UNITED STATES PATENT AND TRADEMARK OFFICE

10/559,621

Office Action Summary	Application No. 10/559,621	Applicant(s) SLUNICK ET AL.	
	Examiner Fannie Kee	Art Unit 3679

DETAILED ACTION

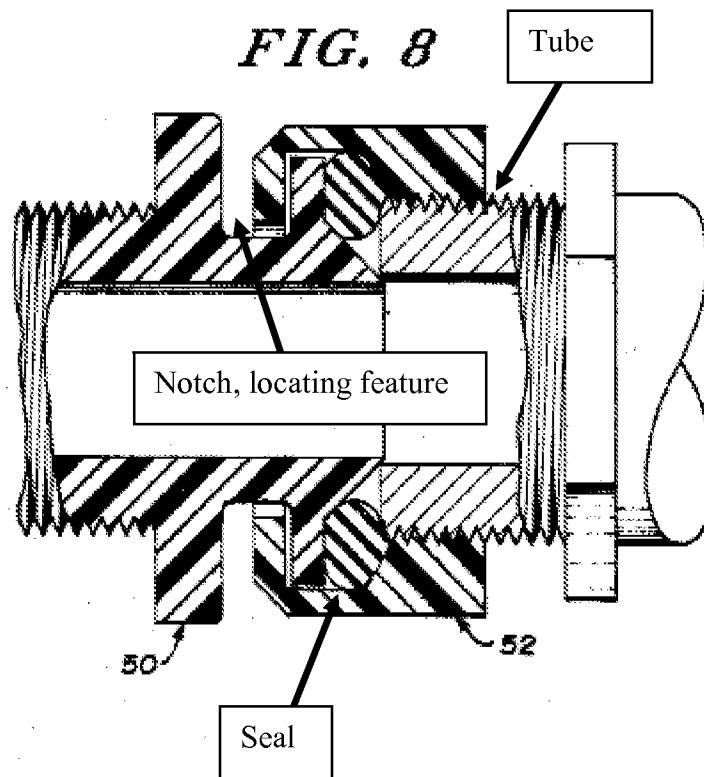
With regard to claim 1, and as seen in Figure 8 below, Bawa discloses a fluid connection assembly comprising:

- a housing (50) including a fluid port, and the housing is made of a first material;
- a tube made of a second material dissimilar to the first material;
- a seal located between the tube and the fluid port;
- a retainer (52) to secure the fluid port to the tube; and
- at least one locating feature having a notch, wherein the notch receives a portion of the retainer to prevent relative rotation between the fluid port of the housing and the tube.

With regard to claim 2, and as seen in Figure 8 above, Bawa discloses the first material being plastic and the second material being metal.

With regard to claim 3, and as seen in Figure 8 above, Bawa discloses the housing (50) being a manifold.

With regard to claim 5, and as seen in Figure 8 above, Bawa discloses the retainer (52) being plastic.

With regard to claim 9, and as seen in Figure 8 above, Bawa discloses at least one of the fluid port and the tube including the at least one locating feature, and the material of the retainer is received in the at least one locating feature to prevent relative rotation between the fluid port of the housing and the tube.

With regard to claim 20, and as seen in Figure 8 above, Bawa discloses said at least one locating feature including a first locating feature and a second locating feature (threads on tube), and said fluid port including said first locating feature and said tube including said second locating feature.

With regard to claim 25, and as seen in Figure 8 above, Bawa discloses the fluid port and the tube being coaxial along a longitudinal axis defined by the fluid port, and the at least one locating feature preventing relative rotation between the fluid port of the housing and the tube about the longitudinal axis defined by the fluid port.

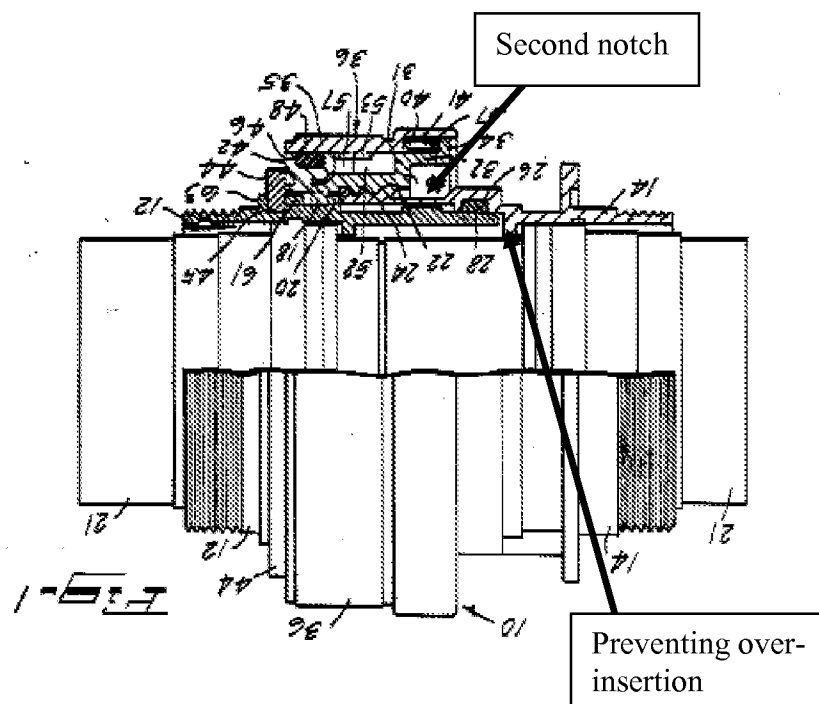
With regard to claim 15, and as seen in Figure 1 below, Paoli et al disclose a method of assembling a fluid connection comprising the step of:

- attaching a fluid port of a housing (12) to a metal tube (14);
- locating a seal (28) between the metal tube and the fluid port;
- forming a first notch (notch at 18) in the fluid port and a second notch in the metal tube;
- retaining (16) the fluid port to the metal tube; and

preventing rotation between the fluid port of the housing and the metal tube by flowing a material into the first notch and the second notch during the step of retaining the fluid port to the metal tube.

With regard to claim 16, and as seen in Figure 1 above, Paoli et al disclose the step of inserting the fluid port (12) into the metal tube (14).

With regard to claim 17, and as seen in Figure 1 above, Paoli et al disclose the step of preventing over insertion of the metal tube during the step of inserting the fluid port into the metal tube.

With regard to claim 18, and as seen in Figure 1 above, Paoli et al disclose the step of retaining includes molding a retainer (16) over a joint of the metal tube and the fluid housing.

With regard to claim 20, and as seen in Figure 1 above, Paoli et al disclose said at least one locating feature including a first locating feature and a second locating feature, and said fluid port including said first locating feature (notch at 18) and said tube including said second locating feature.

With regard to claim 21, and as seen in Figure 1 above, Paoli et al disclose an annular collar (20) of said fluid port including said first locating feature (notch at 18), and a flared end (24) of said tube including said second locating feature.

With regard to claim 25, and as seen in Figure 1 above, Paoli et al disclose the fluid port (12) and the tube (14) being coaxial along a longitudinal axis defined by the fluid port, and the at least one locating feature (notch at 18) preventing relative rotation between the fluid port of the housing and the tube about the longitudinal axis defined by the fluid port.

With regard to claim 26, and as seen in Figure 1 above, Paoli et al disclose a first notch (notch at 18) formed in the fluid port and a second notch formed in the metal tube, and the material of the retainer being received in the first notch and the second notch to prevent relative rotation between the fluid port of the manifold and the tube.
